Enclosure 13 – RAI Response**RAI Letter Dated August 16, 2017****Documents to be Docketed****NRC QUESTION 1:**

System Description and Configuration**NRC QUESTION 2:**

Figure 1 Relationship of Electrical Divisions, FLOW channels, and APRM channels

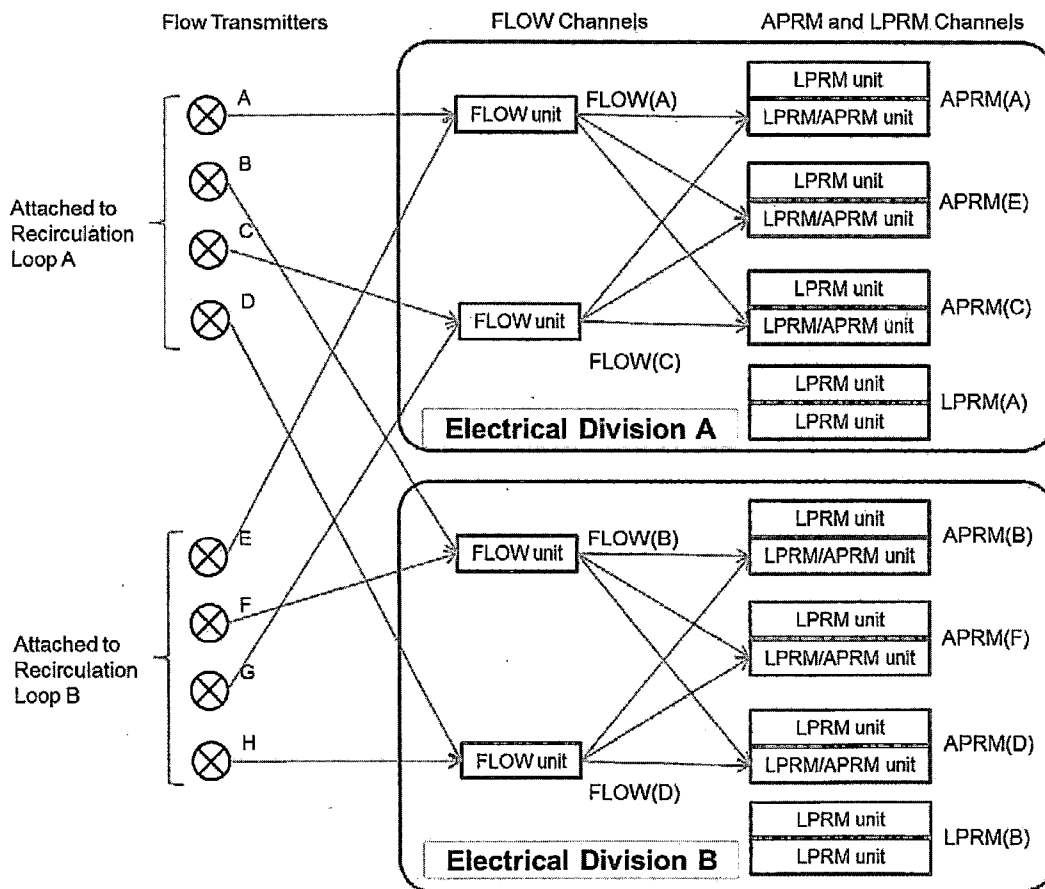
2. (Open Item 80) The licensing topical report (LTR) Section II-2.2.2.3 describes the system configuration. However this section does not describe the configuration for a boiling water reactor (BWR)-5. Instead, the configuration for the BWR-5 is provided in Section II-A-7.1 of the LTR. Also, Section 4.2 of the Equipment Design Specification (EDS) (document No. FC51-3002-1000) identifies the configuration of the Power Range Neutron Monitoring (PRNM) system for one division.

It is the NRC staff's understanding that the description provided in the EDS is for the PRNM system for the Advanced BWR (ABWR), and thus this information can't be used as the configuration for the BWR-5 PRM system. Please address the following:

- Describe the PRM system configuration for each division (i.e., number of local power range monitors (LPRM), units, and modules in each division).
- Provide a figure/diagram showing the PRM system architecture, including the configuration for all divisions. Note that Figures 4-1 in the equipment requirement specification (ERS) and II-A-7-1 in the LTR show the PRM system configuration, but these figures do not identify the separation for each division.

- The BWR-5 PRM system configuration for one channel is shown in Figure II-2-14 in Topical Report (TR) Section II-2.2.2.4. Figure 1 below illustrates the relationship of the electrical divisions, FLOW channels, and the APRM channels described in Section 4.3.1 of the BWR-5 Equipment Requirement Specification (ERS) (FPG-RQS-C51-0001, Rev.7). Each of the BWR-5 electrical divisions has two FLOW units, an LRPM unit, and three LPRM/APRM units. The three LPRM/APRM units are considered three channels.

- b. Figure 1 provides a simple BWR-5 PRM system architecture showing the electrical divisions. As described in LTR Section II-A-7.1, the APRM channels, LPRM channels, and FLOW channels are divided into two electrical divisions in a BWR-5.

For the BWR-5 PRM, Figure 1 in this document shows how each of two electrical divisions (or electrical groups) has the same set of FLOW channels and APRM channels performing the same functions. This configuration meets the redundancy criteria between the divisions and is the digital equivalent of the systems currently installed in the BWRs.

Figure 1 illustrates the configuration of the BWR-5 PRM system. The BWR-5 PRM system is divided into two electrical divisions, each of which has an independent power source. The FLOW and APRM channels in one electrical division operate independently, without receiving any data from the other division. The OPRM channels in a large core BWR use only the data from the division where the OPRM is installed. The OPRM channels in a small core BWR use LPRM data from both divisions (see Toshiba response to NRC Question 6).

Figure 3 Required Response Spectrum

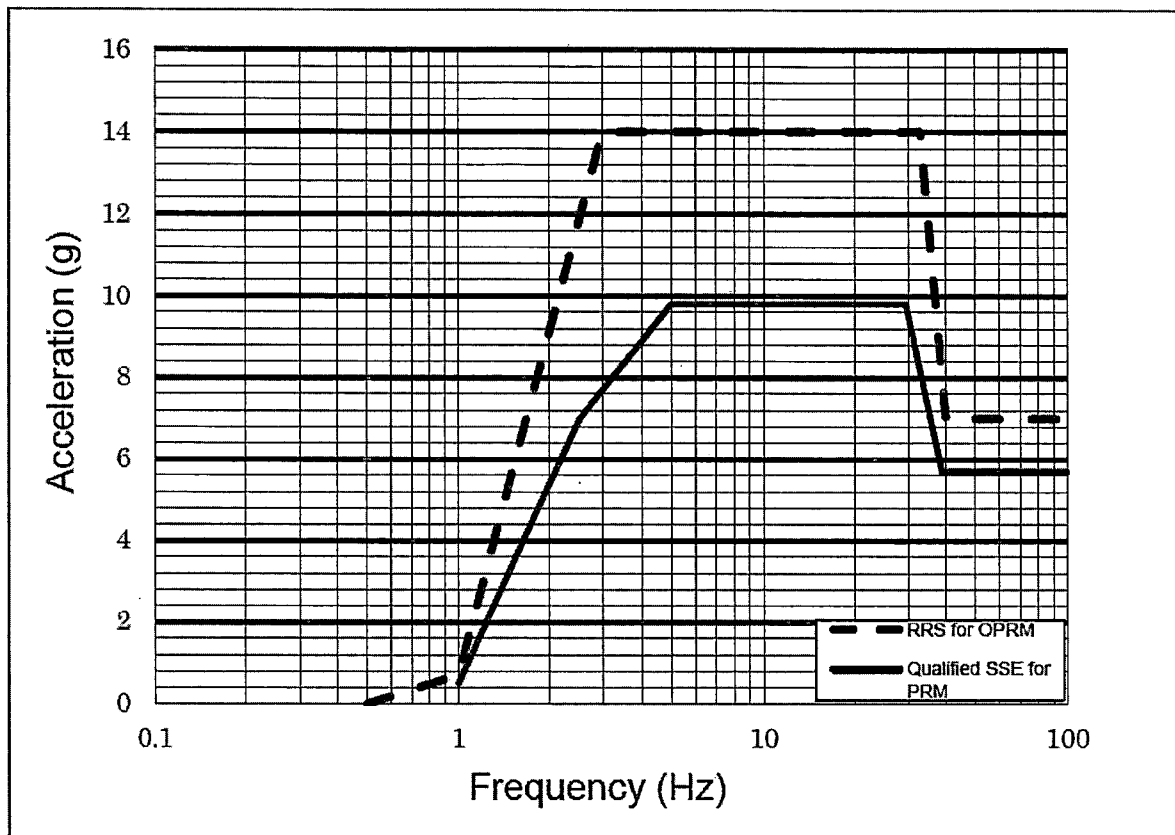
24. (Open Item 105) The Random Multi-Frequency Test results in Appendix A.2 of the Qualification Test Summary Report are hard to read because the gridlines are faint. In addition, the Test Response Spectrum (TRS) fell below the Control Spectrum or Required Response Spectrum (RRS) for at least one point in Figure A.2.6.1. Please provide the following information:

- a. Updated plots in Appendix A.2 of the new version of the Qualification Test Summary Report to show the gridlines or tabulate the breakpoints at one-sixth octave intervals over the frequency range from 1 to 100 Hz for at least Figure A.2.6.1 and one of the operating basis earthquakes (OBEs).

- b. Information on whether Figure A.2.6.1 meets the requirements of Clause 8.6.3.1n of IEEE 344-2004. One point may fall below the RRS by 10 percent provided adjacent 1/6 octave points are at least equal to the RRS and adjacent 1/3 octave points are at least 10 percent above.

- c. An explanation of how the control spectra shown in Appendix A.2 of the Qualification Test Summary Report are consistent with the RRS in Figure II-A-4-5 of the LTR. Additional breakpoints appear to have been added to the EPRI TR-107330 spectrum.

- a. Toshiba will revise and docket the Qualification Test Summary Report (FPG-TRT-C51-0101) by the end of September 2017. The revised Qualification Test Summary Report will include updated plots of Appendix A.2, which shows the gridlines or tabulates the breakpoints at one-sixth octave intervals over the frequency range from 1 to 100 Hz for at least Figure A.2.6.1 and one of the operating basis earthquakes (OBEs).

- b. Toshiba planned to conduct the seismic test with the RRS provided in Figure 4-5 of EPRI TR-107330 dated October 1997. The TRS listed in figures in Appendix A.2 of the Qualification Test Summary Report were achievable. Toshiba considers that exceedances below about 3.5 Hz are generally acceptable based on IEEE Std. 344 2004 Section 8.6.3.1(j) since there are clearly no resonances below 5 Hz. Toshiba evaluated the higher frequency area. Toshiba found that Figure 4-5 of a later version of EPRI TR-107330 is slightly different from Figure 4-5 in the original October 1997 version which is the basis for the current Toshiba RRS. Toshiba evaluated the difference. The later version (available from the EPRI website) provides Figure 4-5 with a narrow peak spectral band. Specifically, the 5% damped SSE response spectrum control points of Figure 4-5 of the later version of EPRI TR-107330 are (1 Hz, 0.42 g); (4.5 Hz, 14 g); (16 Hz, 14 g); (33 Hz, 6.13 g); and (100 Hz, 6.13 g). The original version of Figure 4-5 includes a broader frequency. Specifically, the 5 % damped SSE response spectrum break points of this version of Figure 4-5 are (0.5 Hz, 0.1 g); (1 Hz, 0.8 g); (3 Hz, 14 g); (33 Hz, 14 g); (40 Hz, 7 g); and (100Hz, 7 g). The discussion here refers to the version of EPRI TR-107330 Figure 4-5 of the later version of EPRI TR-107330 as the “narrow” spectrum, and the other version of EPRI TR-107330 Figure 4-5 as the “broad” spectrum.

Because of test table limitation of 9.8 g, Toshiba has had to take exception to the EPRI TR-107330 requirement of 14 g in the PRM testing. The PRM testing was conducted at a laboratory where the table could not satisfy the EPRI TR-107330 peak spectral limits. Specifically, the table could only satisfy a peak spectral demand of 9.8 g. PRM test results show that the “narrow” spectrum demand is satisfied with the following exceptions.

Seismic testing for OPRM was conducted at a different facility several years after the PRM testing. The OPRM testing was conducted with the RRS in Figure II-A-4-5 that is based on the “broad” EPRI TR-107330 spectrum to ensure the test table could meet the seismic demand. The test results exceeded the requirements of the broad spectrum with the exception that exceedances in the frequency lower than 3.5 Hz are acceptable based on Clause 8.6.3.1(j) of IEEE Std. 344-2004 since there are clearly no resonances below 5 Hz.

- c. The control spectrum identified in the Appendix A.2 of the Qualification Test Summary Report is based on Figure 4-5 of EPRI TR-107330 dated October 1997. The seismic shake table at the test laboratory was considered. As mentioned above, EPRI Figure 4-5 is slightly different in the later version of EPRI TR-107330. Toshiba will replace Figure II-A-4-5 in the LTR with Figure 3 below adding the explanation that summarizes the discussions in Item b. above, and also replace the corresponding figures in the Qualification Test Summary Report and ERS with the additional explanations so that they will be consistent each other.
